195AUG P 29361
A Repair

SEWAGE DISPOSAL SYSTEM

MARYLAND STATE DEPARTMENT OF HEALTH*

PROPERTY OWNER Mr. & Mrs. Paul Welch

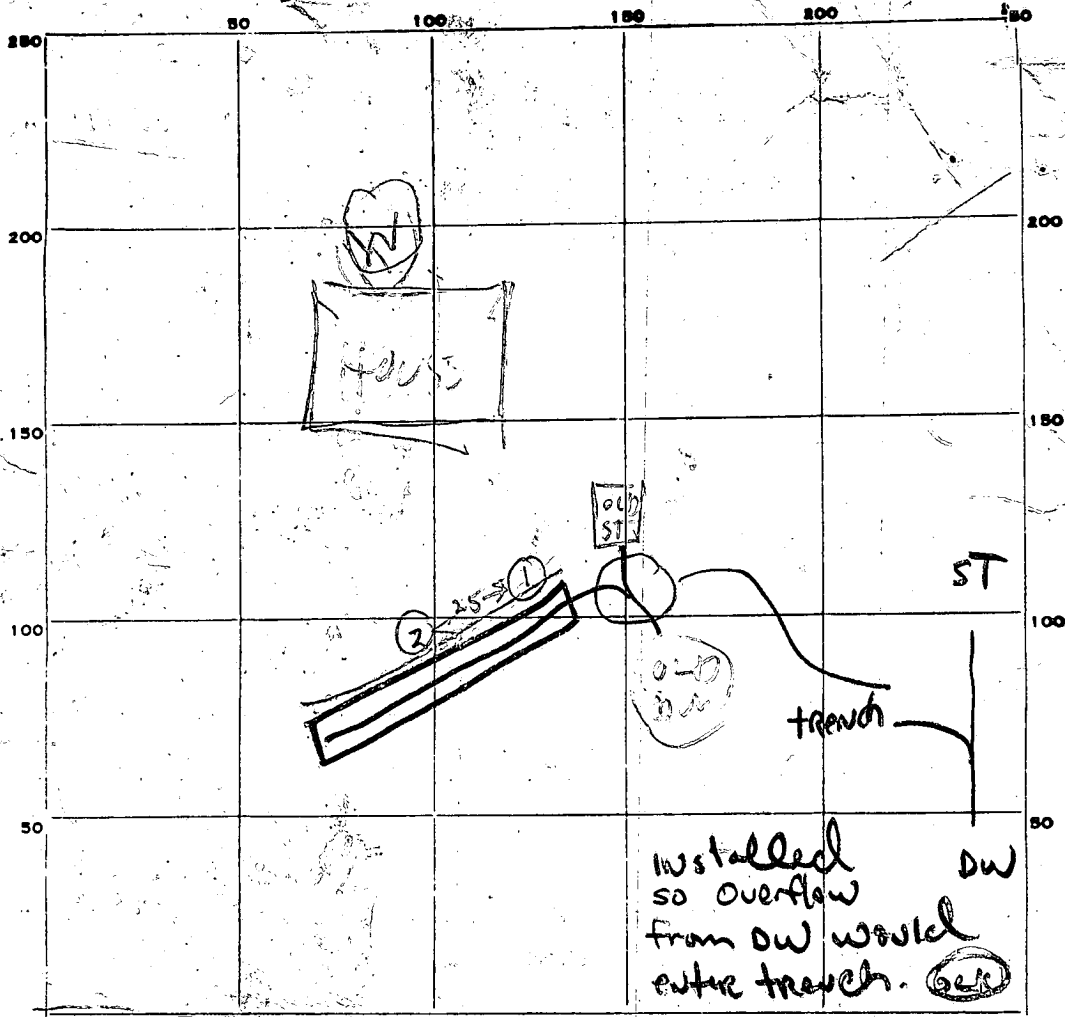
REPAIR - Call for an appointment when ground is opened up and Sanitarian will recommend repair system.

50 FT LONG 10 TO 11 FT DEEP FILLED WITH 7 FT STONE INLET TO DITCH 3 FT DEEP

PLANS APPROVED BY Palmer F. Wine DATE 1/2/79
COVER NO WORK UNTIL INSPECTED AND APPROVED. RUN DITCH OFF OLD TANK

REMARKS HOLE ① - 11 FT DEEP - TOP 4 FT CLAY BOT 7 FT SAND

HOLE ② - 10 1/2 FT DEEP TOP 3 FT CLAY BOT 6 1/2 FT SAND 1/11/79 130 RH

SOIL OK 1/11/79 230 PM RH DITCH DUG

ADD STONE TO DITCH & CALL RHODGES

19 JAN 79 - Approved corrugated pipe but no hold down stakes.

However sufficient gravel cover (6" → 1") to stabilize. OK to backfill. (GLK)

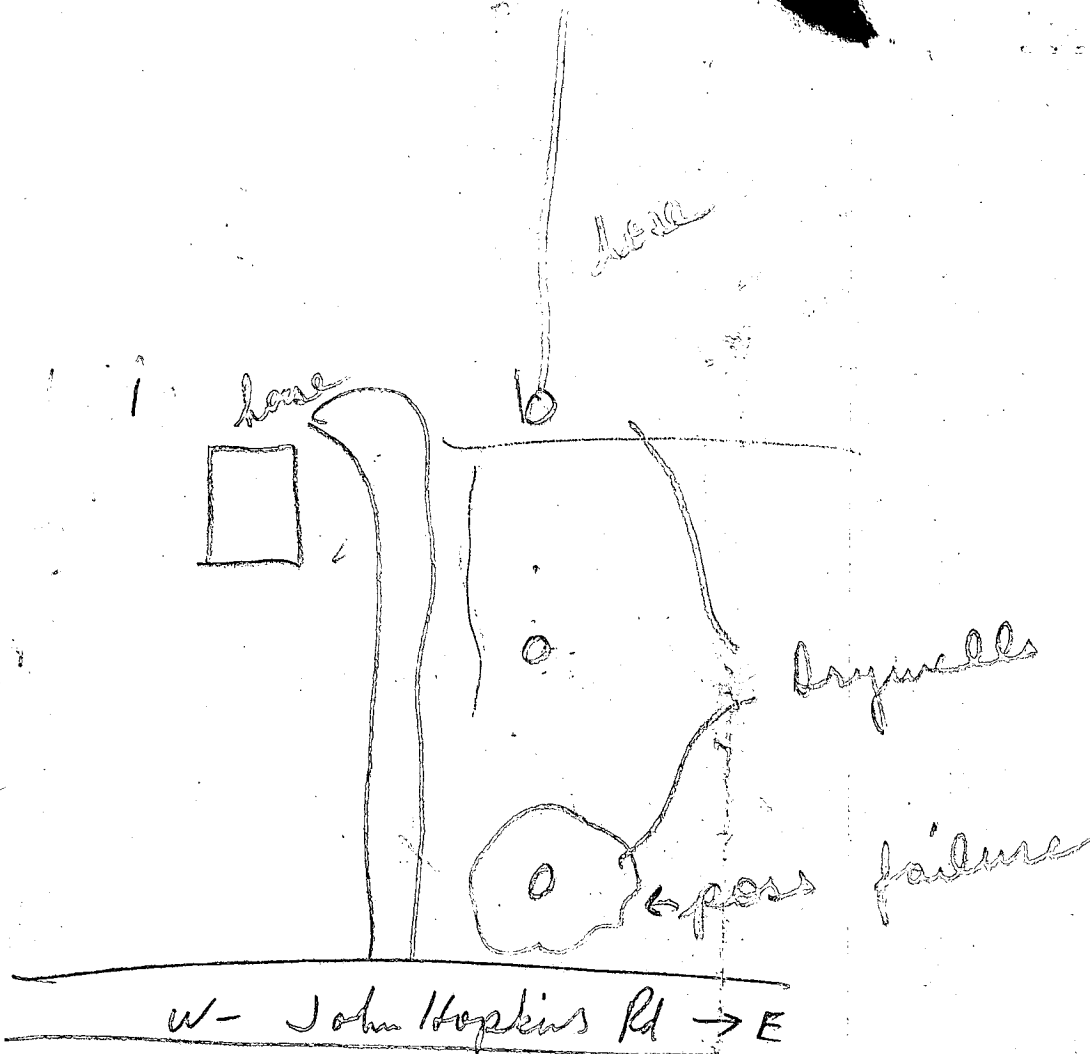
12/27/78 - No record of septic system
Check out per D. W. M. / R.
at 2455
N 59° 53' W

Applicant indicates that the D.W. has been emptied for years with our advice as to the legality. Will continue to pump it out and do work without a permit if necessary. advised them that it is illegal RDB
